Ser. No. 09/650,388

Response to Office Action of 18 October 2002

Atty Docket 115699-15

Figure 4b

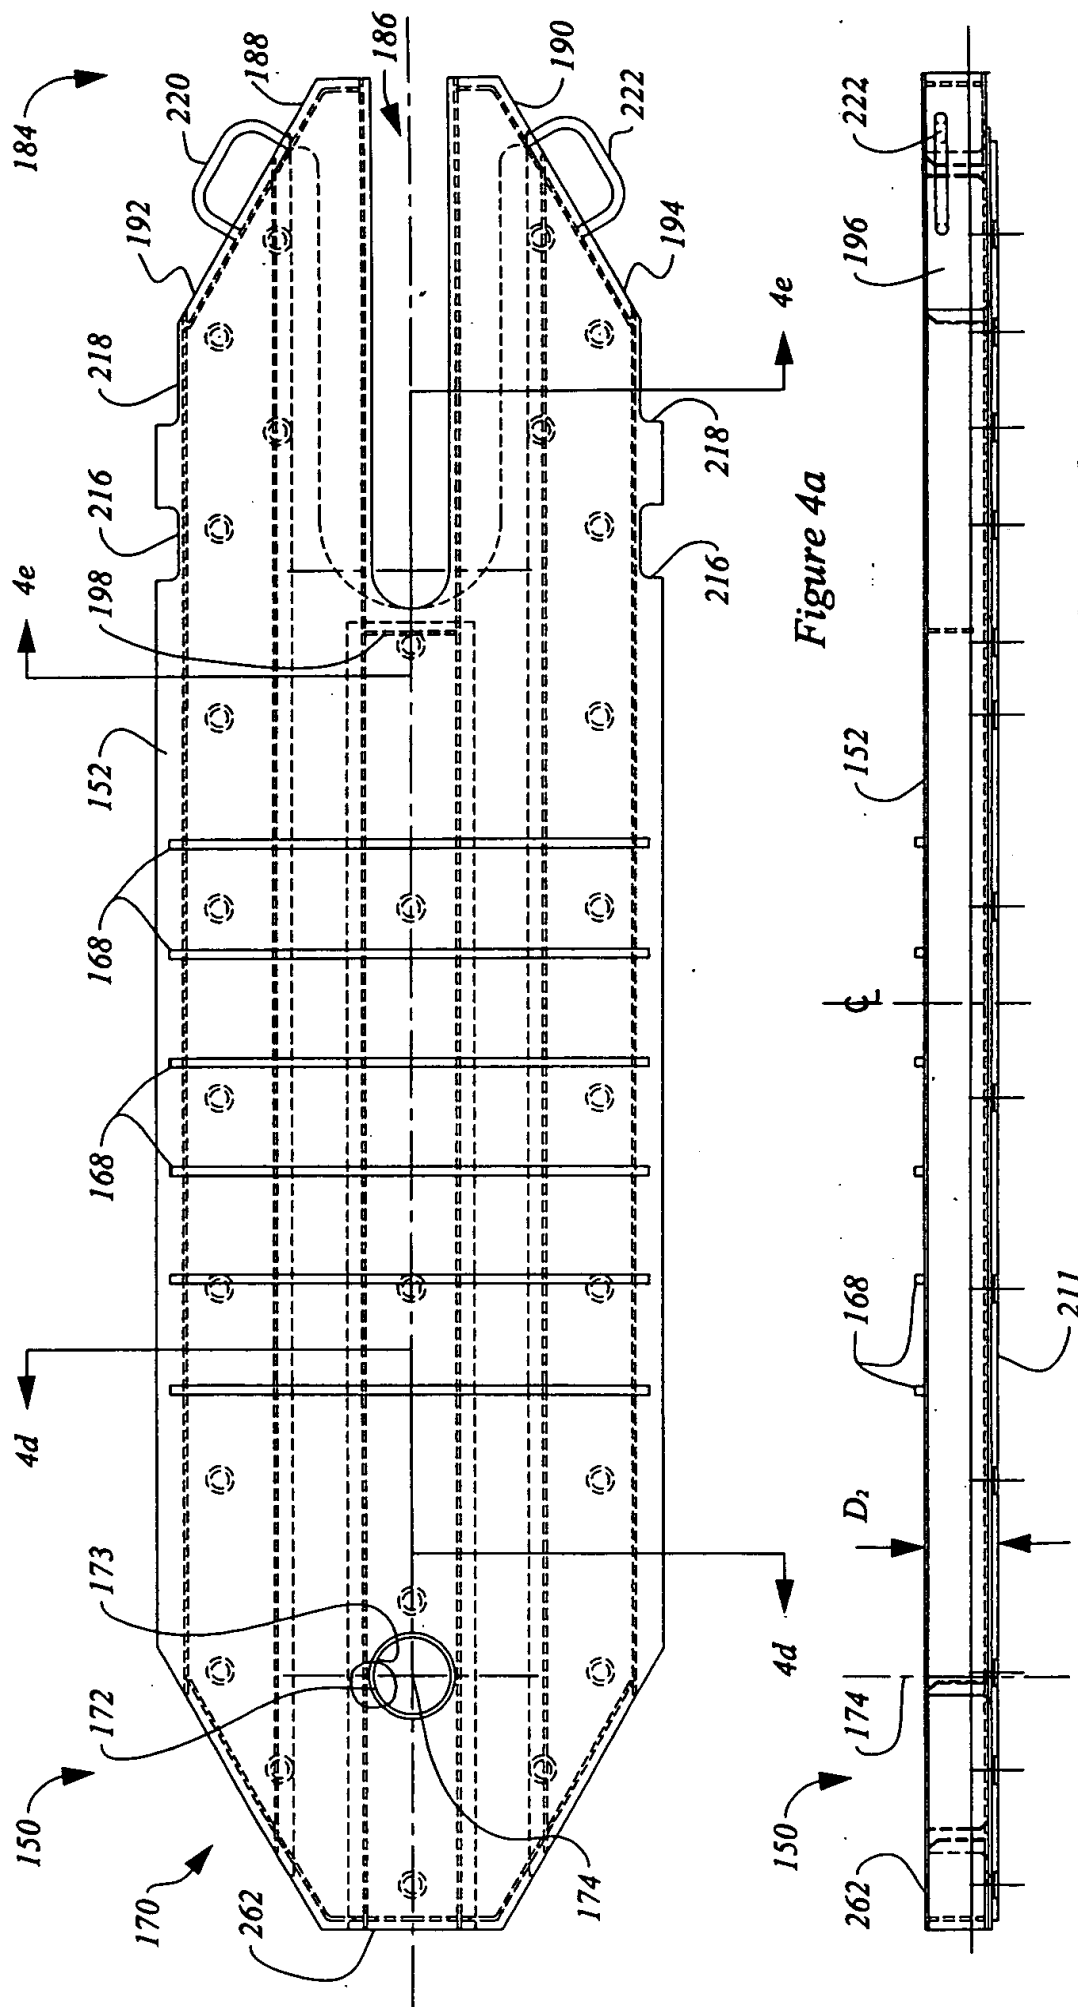
The Examiner has objected to the drawings for failing to show items **172** and **173** to be a pair of aligned holes, as indicated on page 20, line 17. This feature is indicated in Figure **4a** which shows a top view of the bridge plate. The circumference of the aligned holes are indicated as items **172** and **173**. The drawing has been amended to show the circumference of the hole in sheet **152** as item **172** and the circumference of the hole in plate **162** as item **173**. Note that the aligned holes **172** and **173** have been indicated in this manner in Figure **4a** for the purposes of clarity.

The Examiner states that claim 19 refers to a plastic pad mounted to the bottom flange of the bridge plate but that this feature is not indicated in the drawings. Applicant submits that this feature is presently shown in Figure **4b**, as item **211**. In addition, this feature is indicated in Figures **4c**, **4d** and **4e** as item **211**. The applicant respectfully submits that no further amendment to the drawings is required at this time.
